**From:** Willis, Stephanie  
**Sent:** 14/08/2024 9:41:33 AM  
**To:** Council Northernbeaches Mailbox  
**Cc:** Chris Gough; Therese Edwell; Vatala, Stephanie  
**Subject:** TRIMMED: FW: Northern Beaches Council ats Asia Digital Investments Pty Ltd | 1102 Barrenjoey Road, Palm Beach | Submissions on behalf of Ms Rydstrand [DENTONS-Documents.FID10661516]  
**Attachments:** 107852069\_1\_Dentons Submission - 12 April 2024.PDF;  
107852273\_1\_Annexure A - Mr Chambers submission.PDF;  
107852301\_1\_Annexure B - Mr Davies Submission.PDF;

**Northern Beaches Council ats Asia Digital Investments Pty Ltd**  
**Land and Environment Court Proceedings No. 2023/242901**  
**Property: 1102 Barrenjoey Road, Palm Beach**

**Annexure A – Letter from Robert Chambers of BBC Planners dated 12 April 2024**

## VIEWPOINT 07

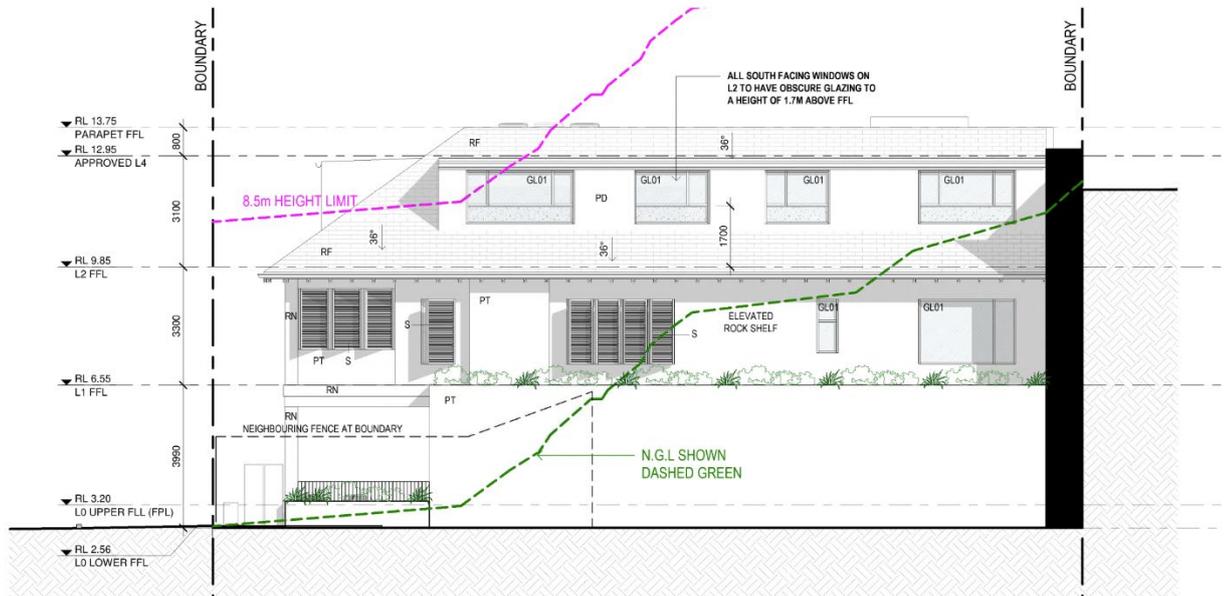
As the front setback at the proposed building's south western corner has been significantly reduced, the northern outlook from the dwelling on our client's property is now more occupied by the proposed building as shown on Viewpoint 7 overleaf.

The south western corner of the building in the amended proposal is, in fact, completely different to the previously proposed south western corner. The terrace (1.0m deep) of the main bedroom of Apartment A3 on Level 1 was setback around 6.0m from the front boundary. Now, the balcony (3.0m deep) extends to within 2.0m of the front boundary. When this is combined with the amended proposal's reduced southern side boundary setback, the amended proposal will appear much bigger and bulkier when seen from my client's property and obscure more of the northern outlook.

The front setback in the south western corner should be increased to at least 6.0m measured to the balcony line, so as to lessen the bulk and scale and ensure my client's northern outlook is not obscured.

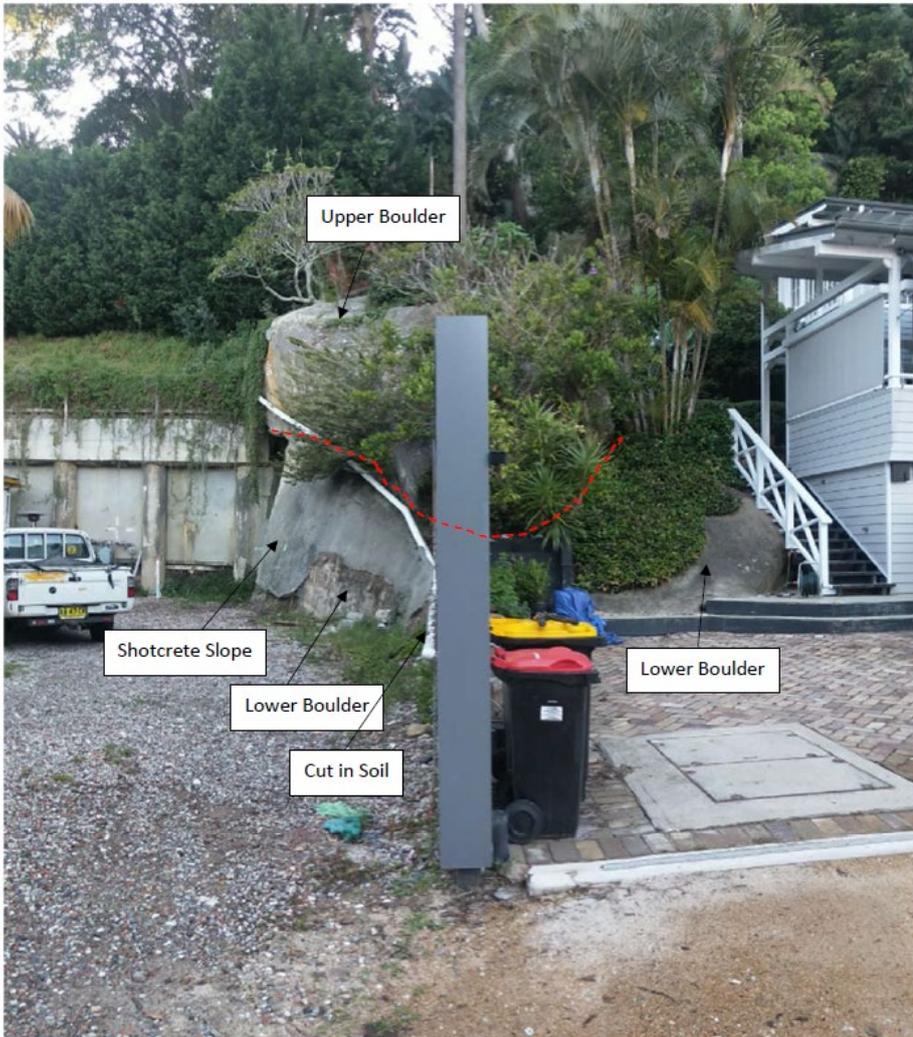
The proposed building height is excessive. The redevelopment already approved on the development site (which the Applicant says has been physically commenced as a result of geotechnical investigations having been carried out) exceeds the 8.5m height limit in PLEP 2014 by 1.655m or 19.4%. The new proposal exceeds the 8.5m height limit by approximately 3.0m or 35%.

In addition to being non-compliant with the building height limited in PLEP 2014, the proposal is out of character with the surrounding area, and is incongruous in height, scale and bulk when compared to our client's property (and to Barrenjoey House).
